# Value Engineering Study Report

*Projects – STP-2387(4) & CSNHS-0007-00(421)  
P.I. No. 542070 & P.I. 0007421*

*Widening of SR 251  
Reconstruction of the I-95 and SR 251 Interchange  
McIntosh County*

RE: Submittal of the final Value Engineering Report  
Projects – STP-2387(4) & CSNHS-0007-00(421)  
McIntosh County  
P.I. No. 542070 & P.I. No. 0007421  
Widening of SR 251 and Reconstruction of I-95 and SR 251 Interchange  
PBS&J Project Task Order No. 26

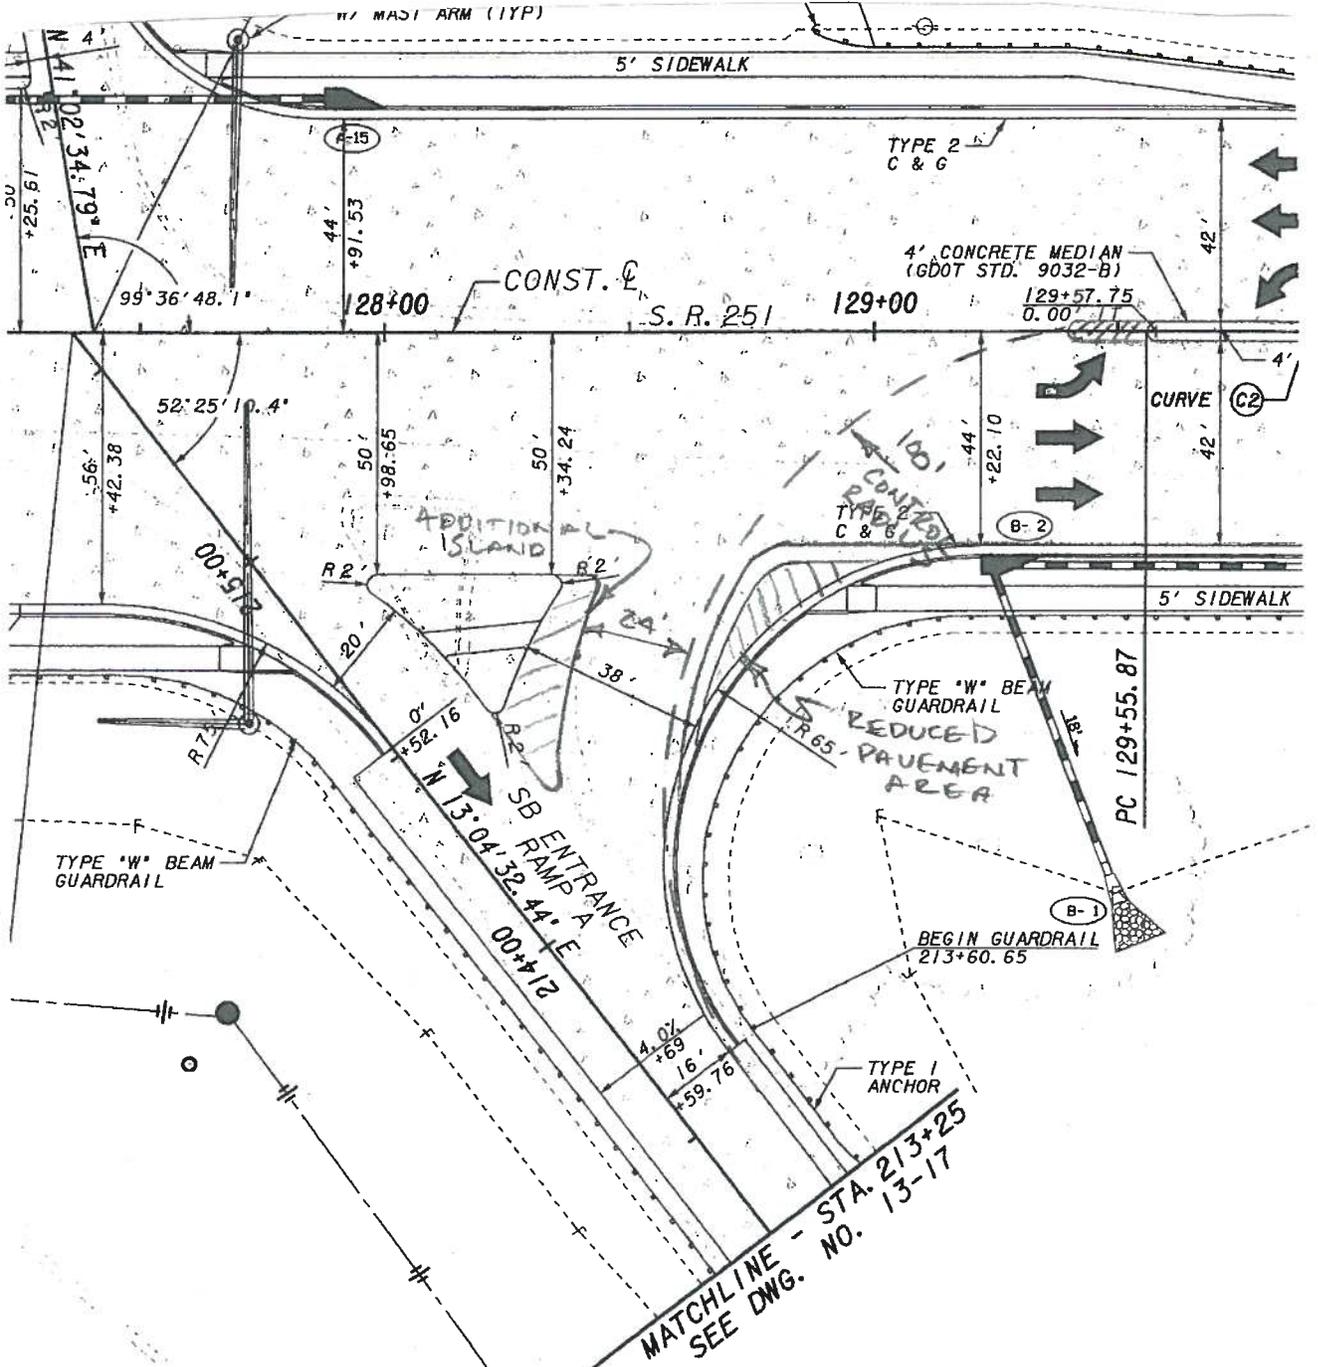
By modifying the geometry it has to positive operational effects. It moves the stop bar closer to the signal and it reduces the amount of “uncontrolled” pavement at the ramp throat. By having a ramp throat that is excessively wide(38’) it will encourage and/or allow unpermitted dual left turns, illegal parking or other improper turning movements.

DESCRIPTION: **REDUCE GAB THICKNESS FOR CONCRETE PAVEMENT** SHEET NO.: 1 of 4

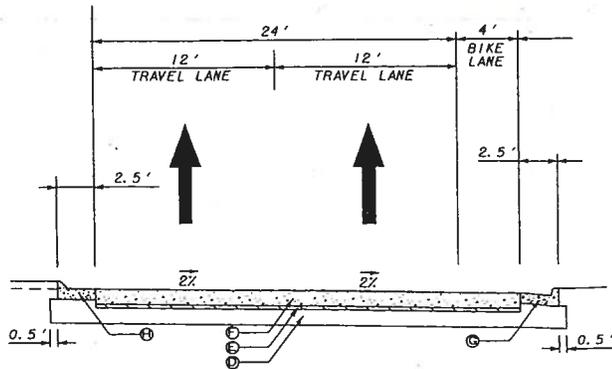
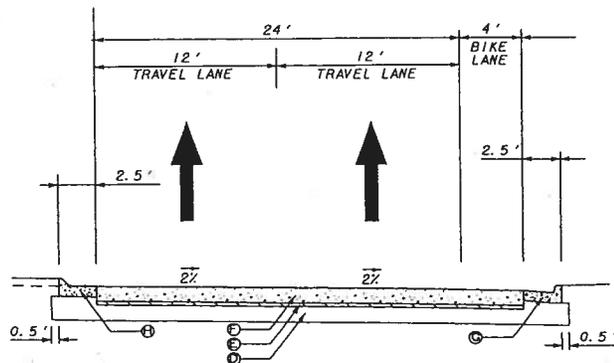
It was inferred from statements in the pavement design that a “generic” design section for Interstate Ramp was utilized. Due to the low overall traffic volumes and low percentage of truck traffic for this interchange 6 inches of GAB and 330# of AC interlayer in lieu of 12 inches of GAB and 330# of AC interlayer may be more reasonable

DESCRIPTION: **DELETE BIKE LANES**

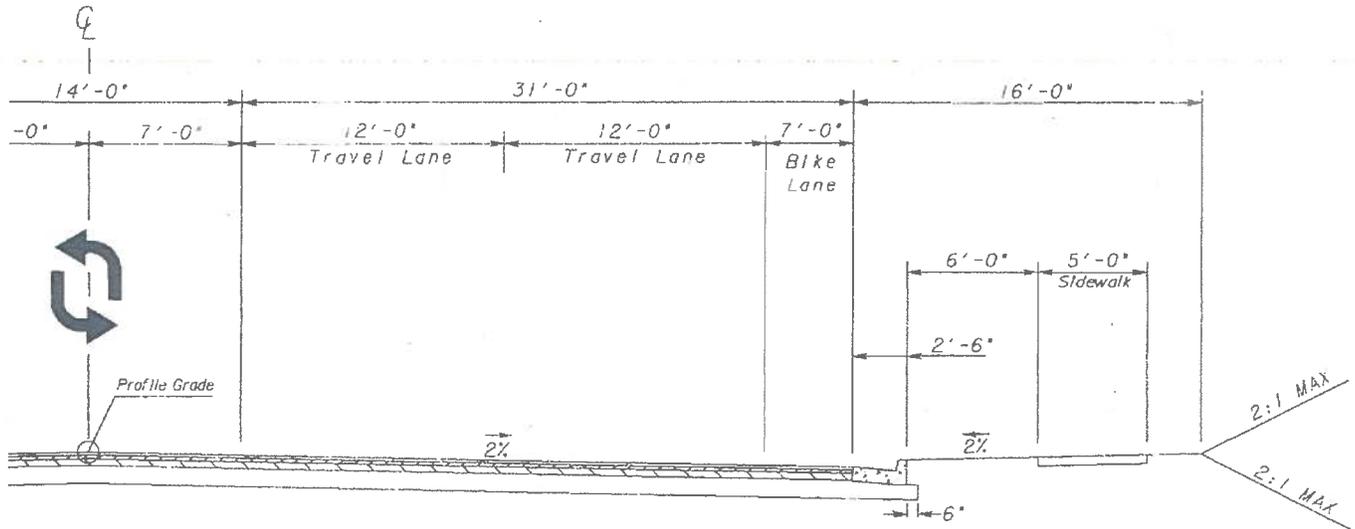
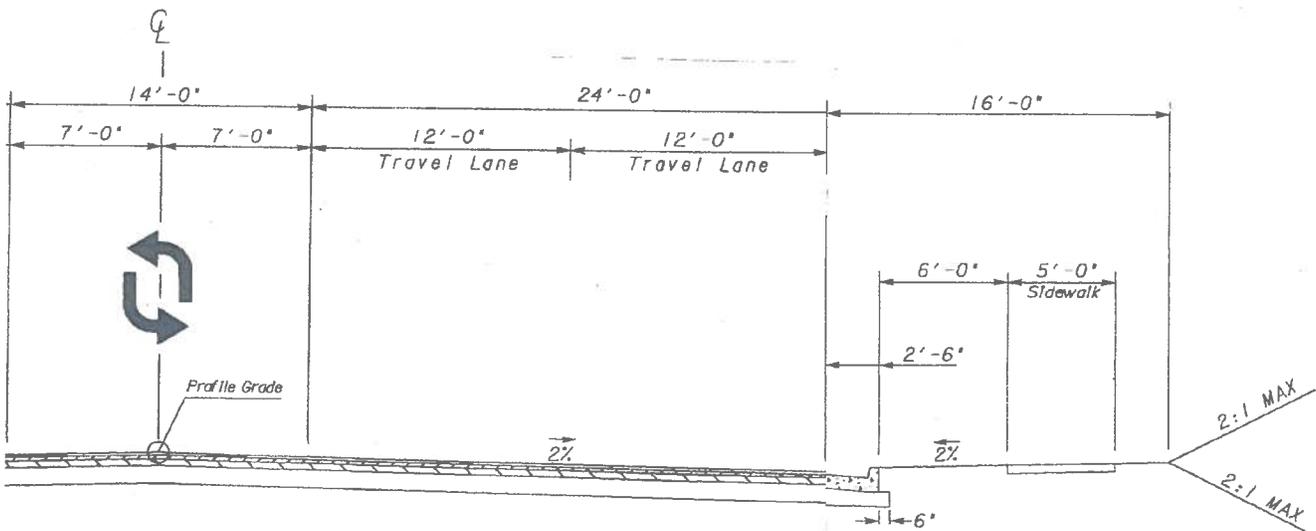
The alternative would delete the bike lanes. Currently, there is no known requirement for bike lanes at this location.

The proposed design provides a 4' and 7' bike lane in each direction for bicyclists adjacent to trucks, trailers, and automobiles moving at 45 mph. Discussions during the designers' presentation indicated that there was not a "requirement" for the bike lanes, but that since there are bike lanes existing on US 17, a terminus of the project, the thought was to provide a route for them to the existing outlet mall on the west side of I-95. Other possible usage could be by folks riding their bikes from the trailer park to the mall. The current design for the bike lanes between I-95 and US 17 has been oversized (from 4' to 7') to accommodate the future changing of the proposed 5 lane to a 4 lane with raised median. It may be reasonable to decide at this time whether to construct a 5 lane or a 4 lane raised median section, and to not spend the money to oversize something which may not occur.

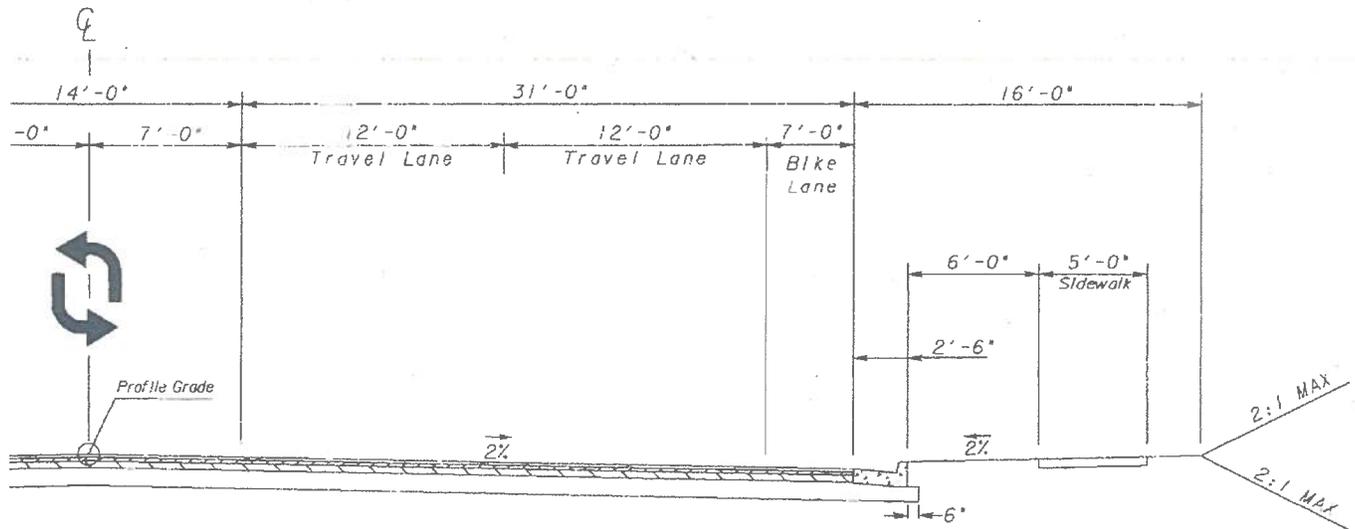
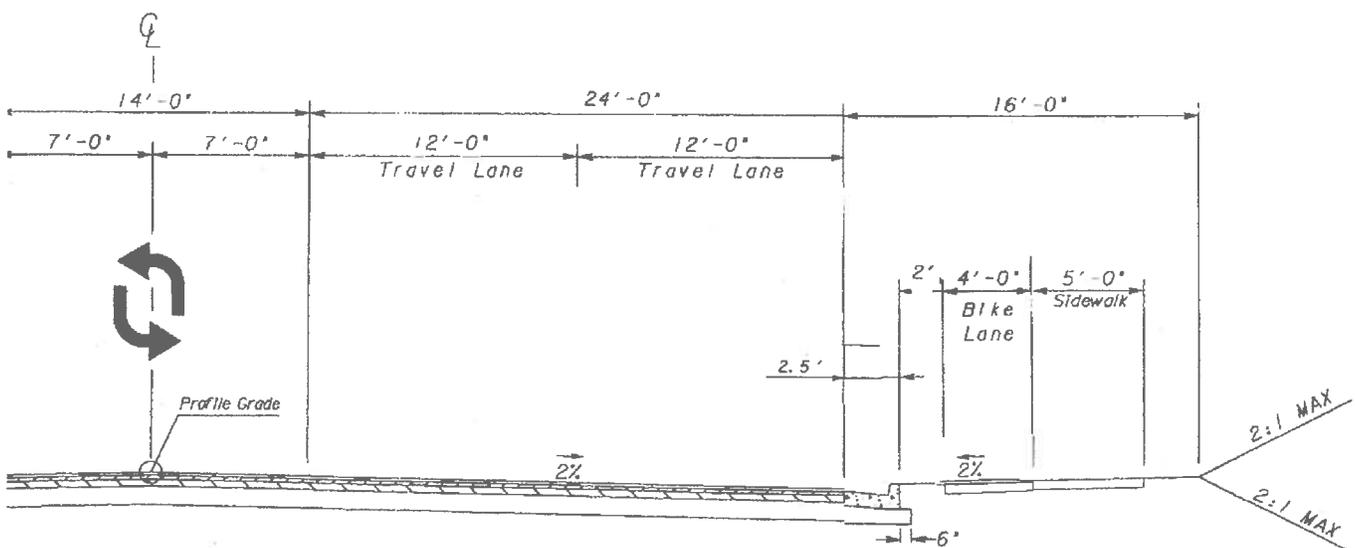
The proposed design would locate the bicyclists adjacent to trucks, trailers and automobiles. By removing them from the travel lanes, the safety would be increased. There are only a minor number of driveways that would have to be navigated by the cyclists.

There are 4' bike lanes in each direction from Sta. 103+00 through the beginning of the NHS project to Sta. 130+57.41 the beginning of the bridge. The alternative is to remove the bike lanes from the roadway deleting the 4' to 7' widths and providing 4' of 4" concrete behind the curve.

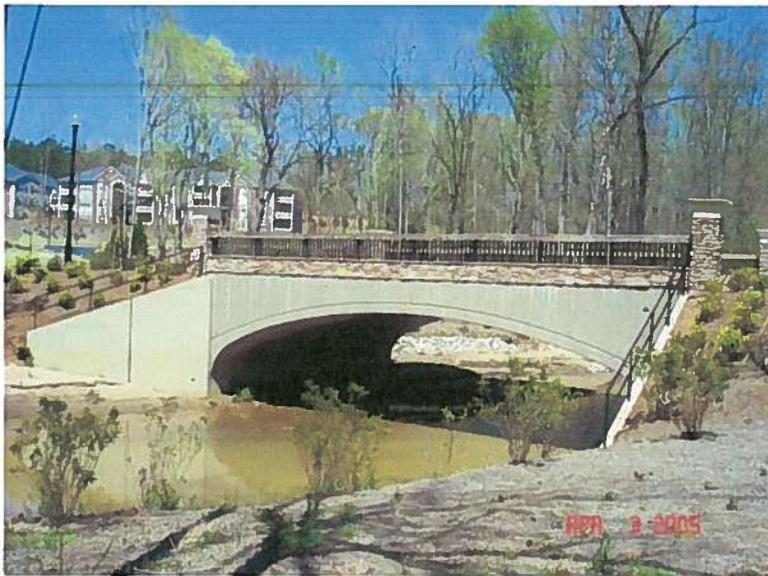
CONSPAN pre-cast culverts are a proven construction option of choice to many agencies (DOT's and Municipalities). The ability of the system to provide larger spans and the ease of construction can be beneficial to the situation in this project where wetland mitigation and stream bed remediation may be concern.
